FINAL
MONITORING REPORT (MY2)

SLINGSHOT MITIGATION SITE
Rockingham County, North Carolina

Response to Monitoring Year 2 (2021) DMS Comments

Slingshot Mitigation Site
Cape Fear River Basin – CU# 03030002 – Rockingham County
DMS Project ID No. 100058
Contract # 7525

**CURRENT
CONDITIONS
PLAN VIEW**

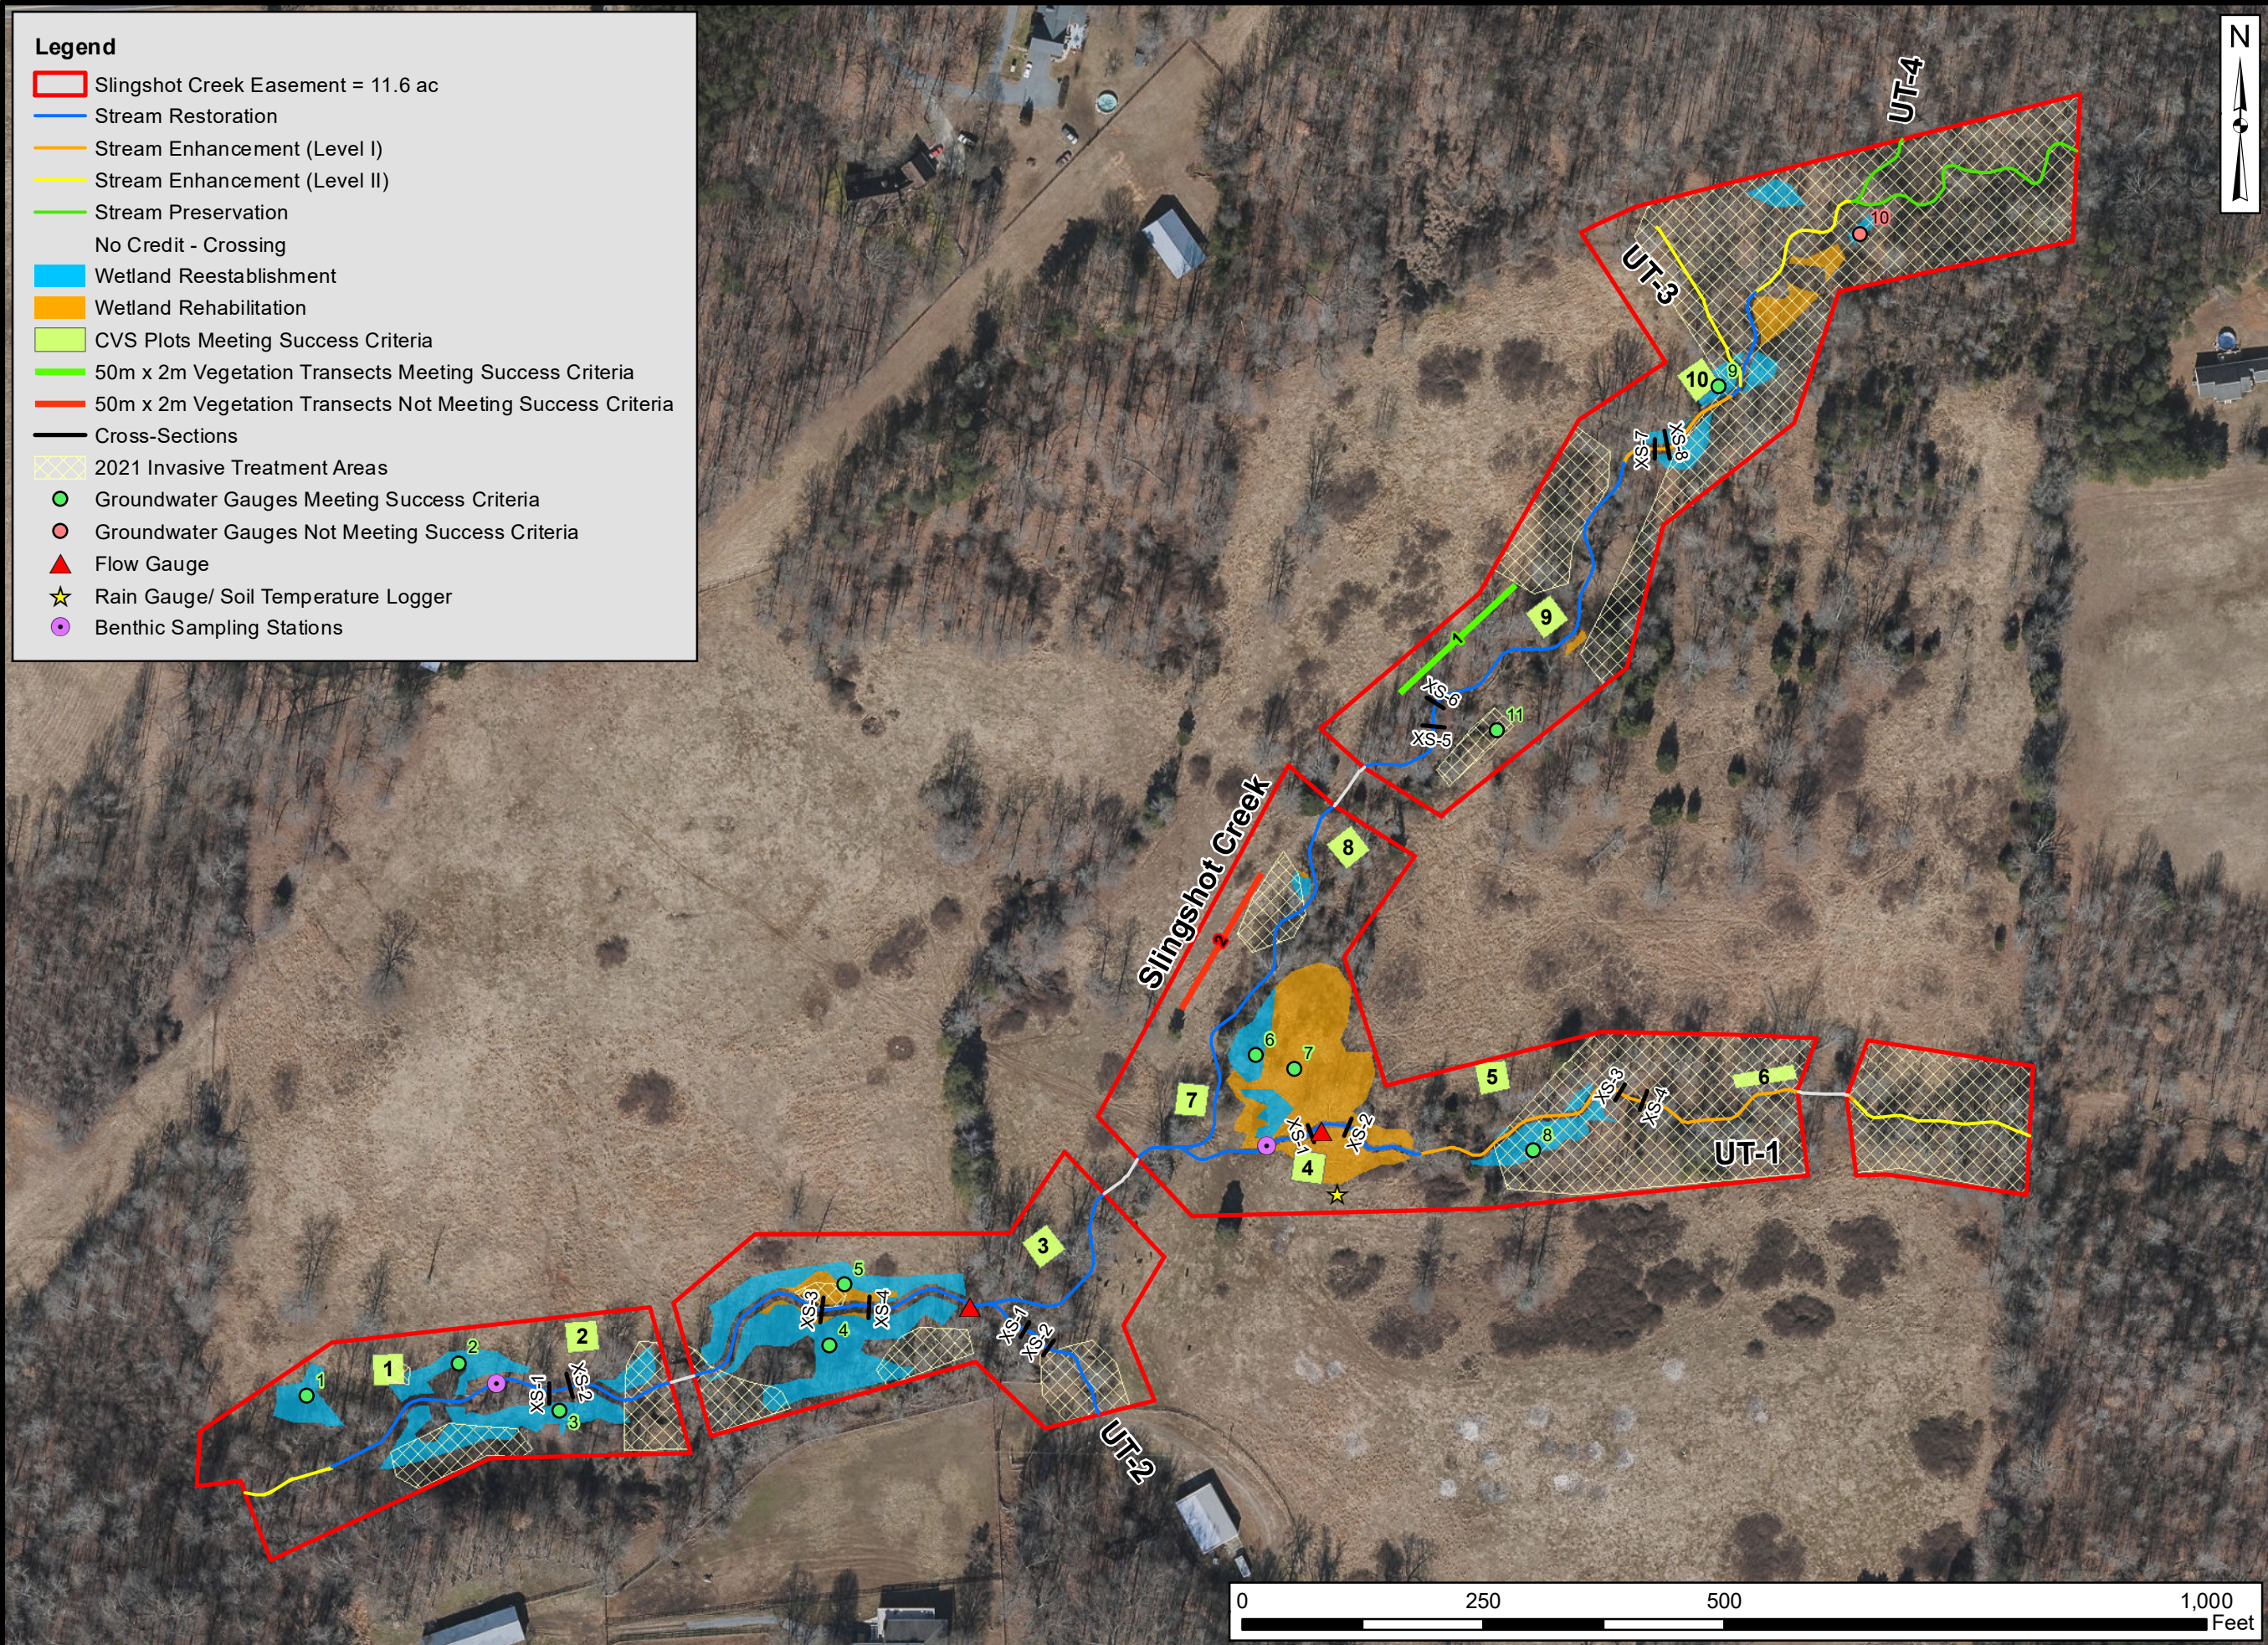
1. The monitoring summary's Site Maintenance Report table shows three instances of invasive and nuisance vegetation management during the monitoring period. The treatment locations should be shown on the CCPV as points or polygons and areas shown on Table 6.
[Response: Invasive treatment areas have been included on the CCPV and Table 6.](#)

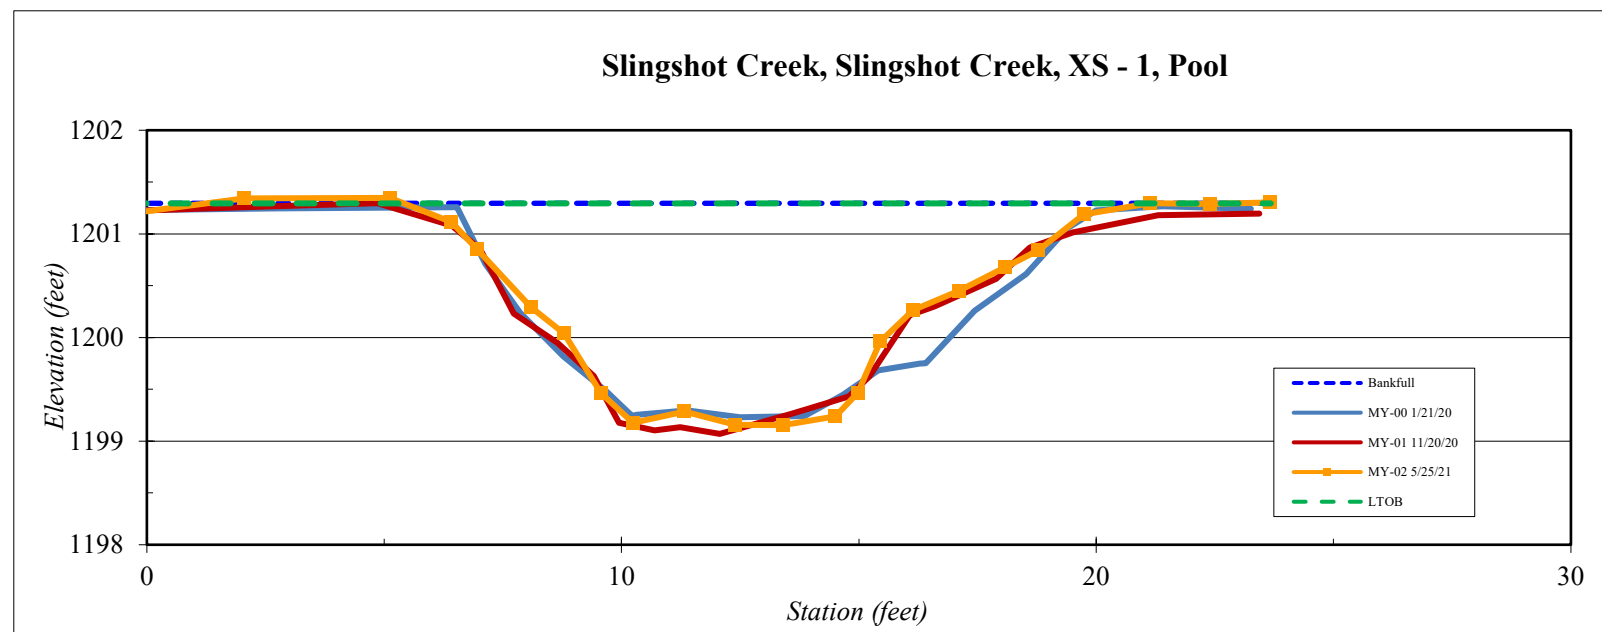
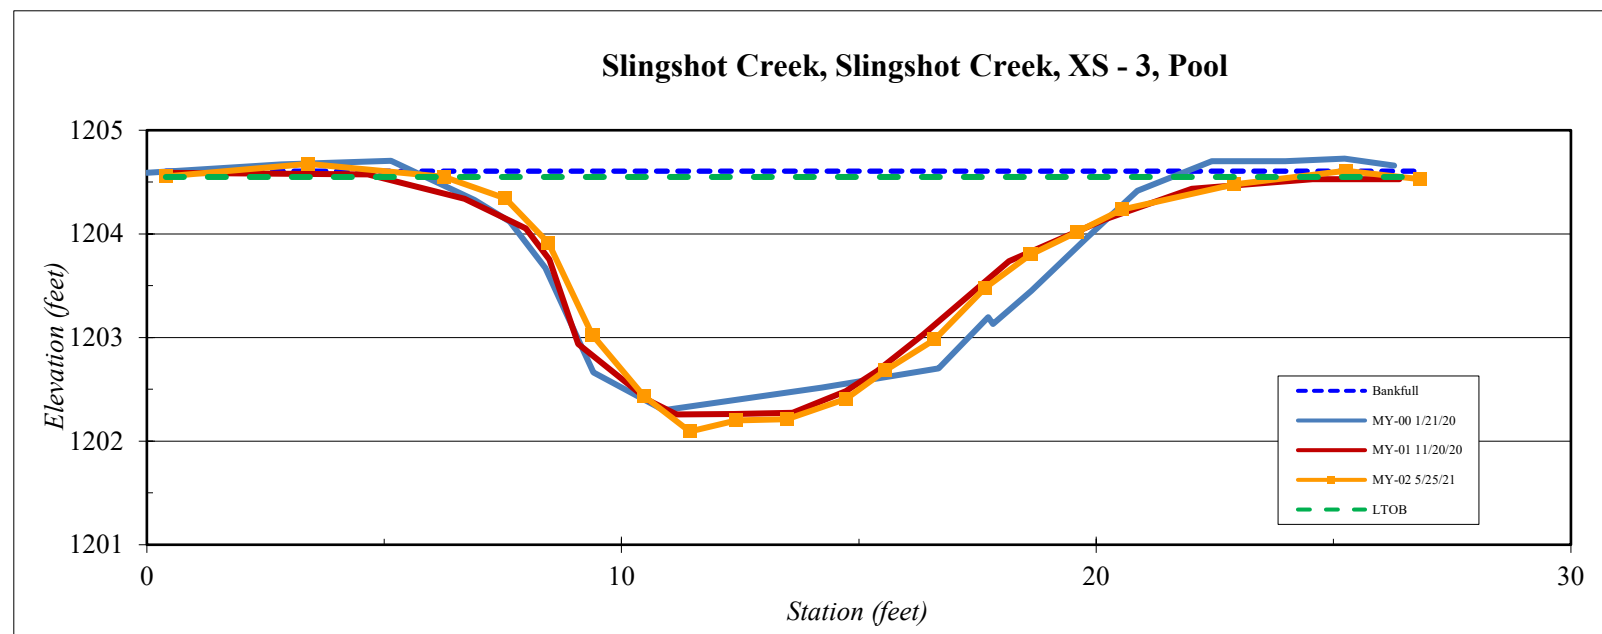
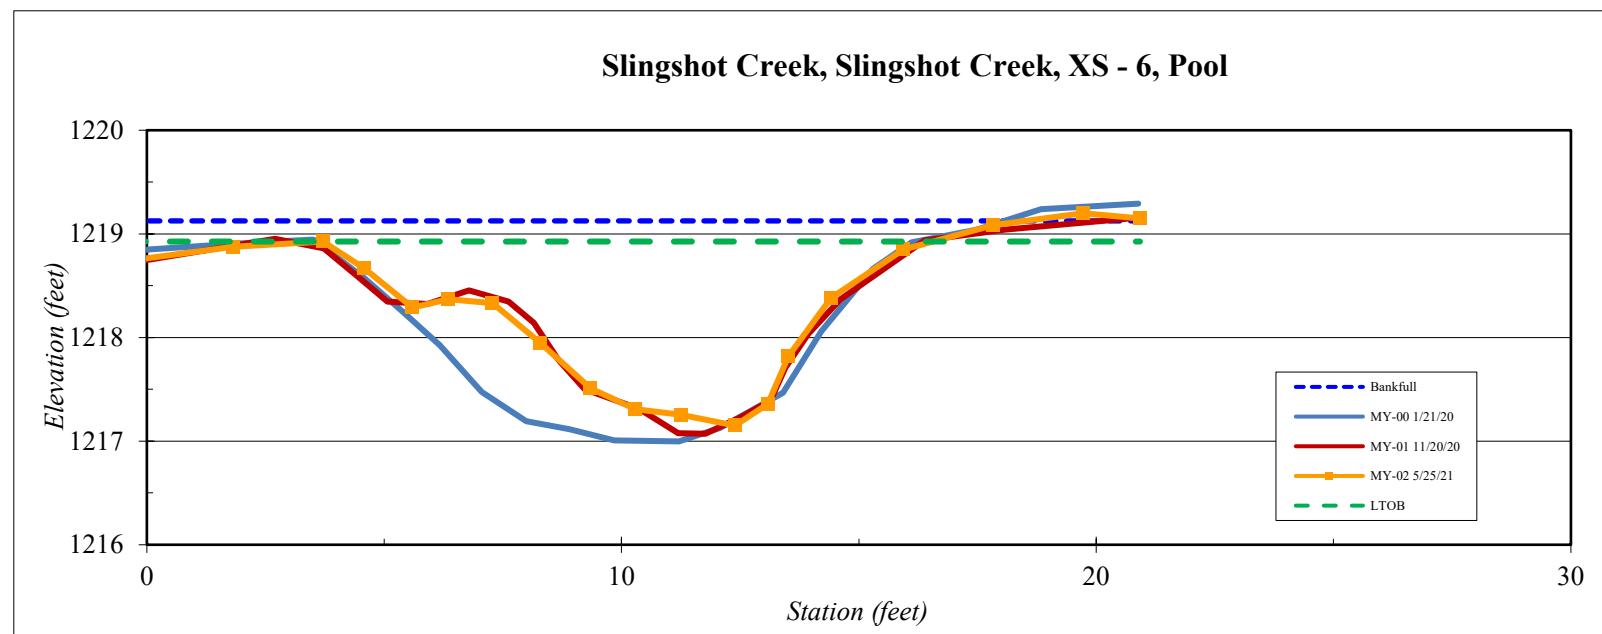
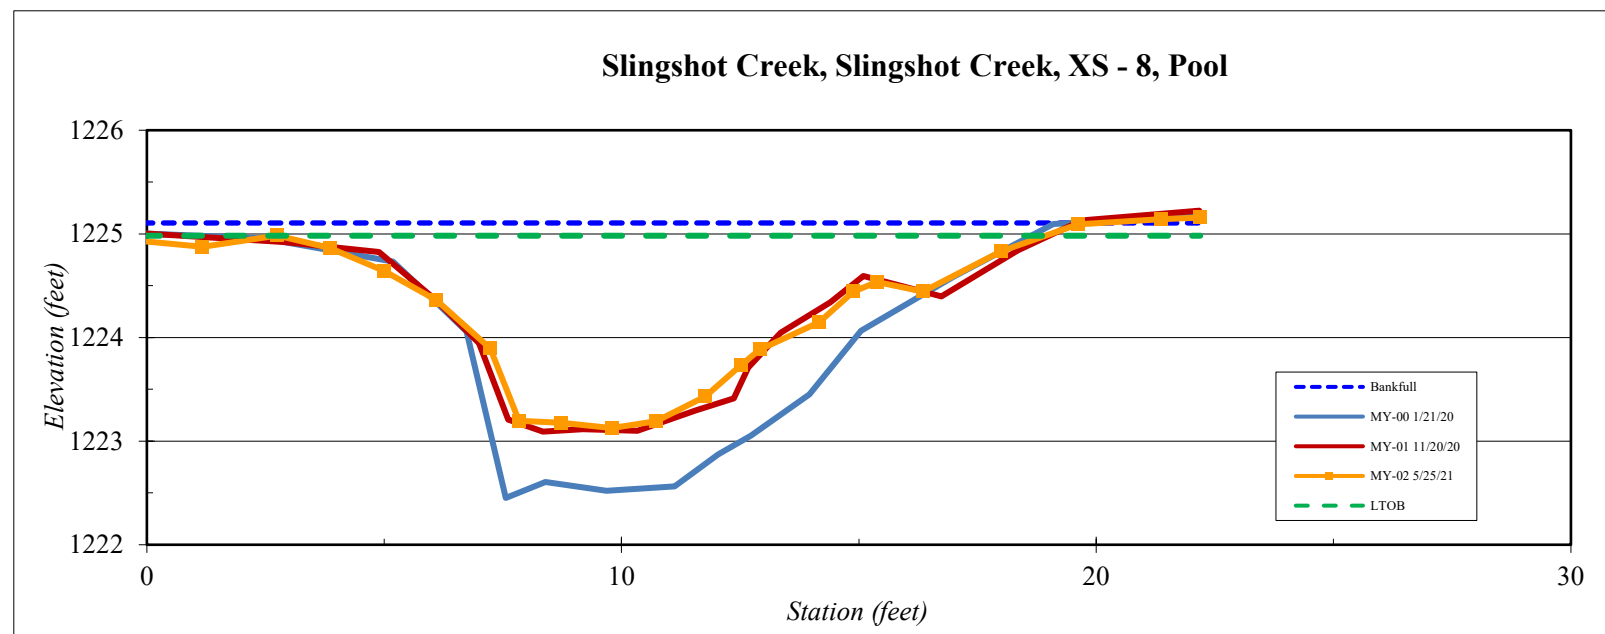
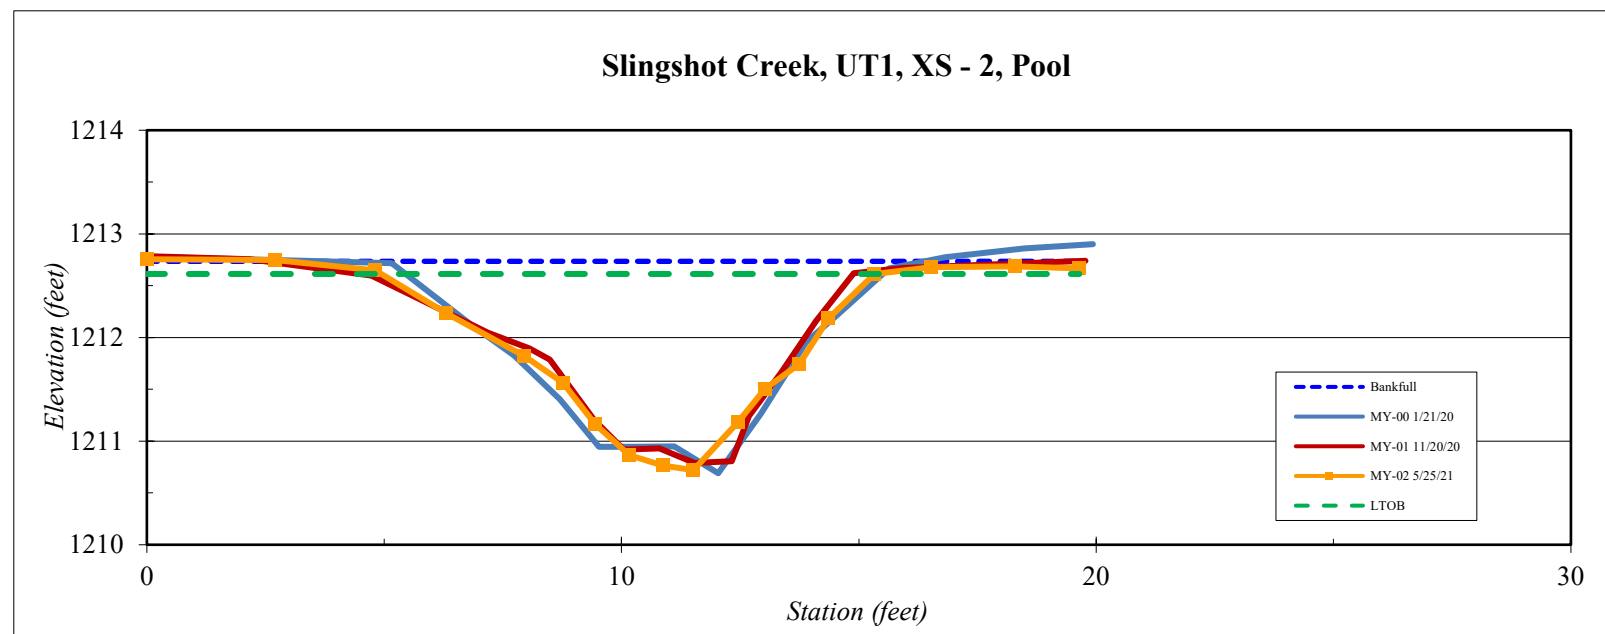
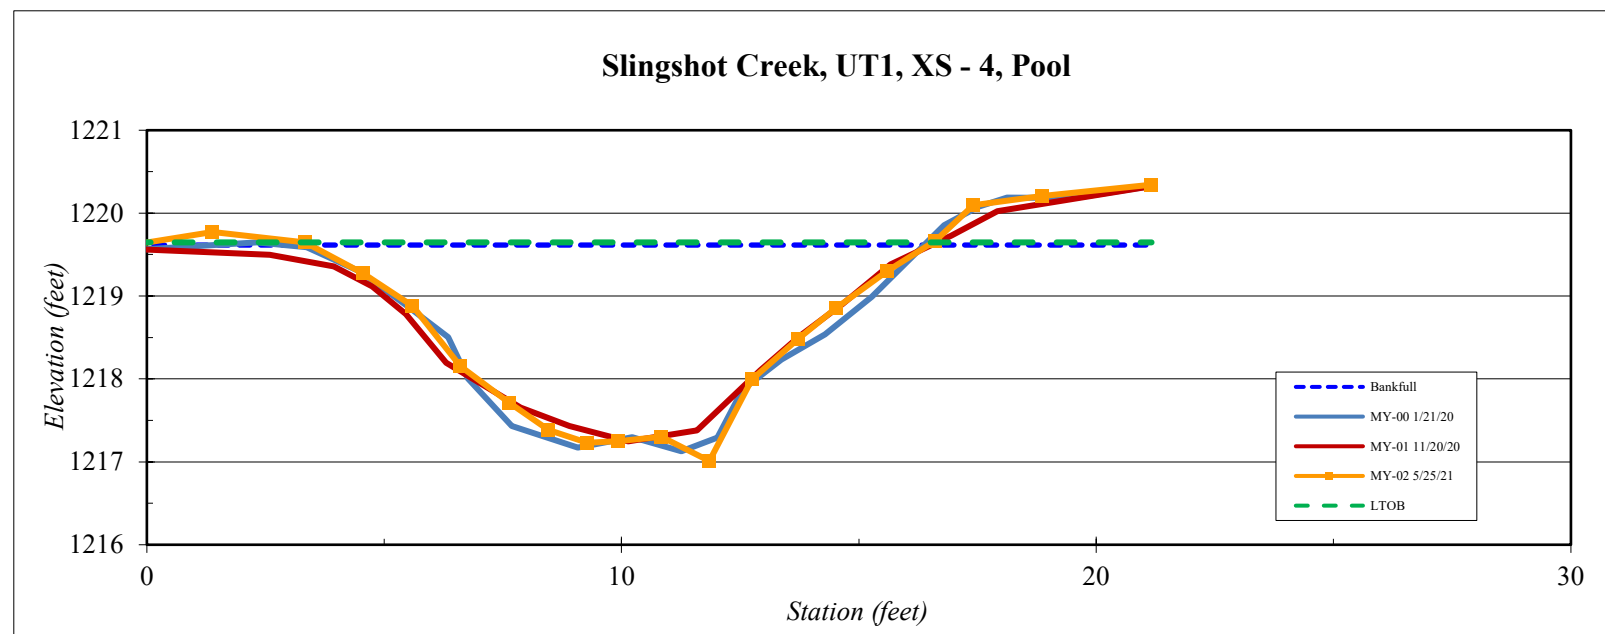
2. Table 12 – This Table should include the current cross sectional area, i.e., the LTOB cross sectional area. The "Cross Sectional Area Between End Pins" row could be replaced with LTOB cross sectional area. This should also be reported with the summary data associated with the cross section graphs. We also recommend displaying the LTOB on the graphs as a line instead of a point for easier comparison with Bankfull based on MYO XSA.
[Response: The row "Cross Sectional Area Between End Pins" was replaced with "LTOB Cross Sectional Area" in Table 12. Additionally, a row for LTOB Cross Sectional Area" was added to the cross-section figures. The point for LTOB on the graphs was replaced with a line.](#)
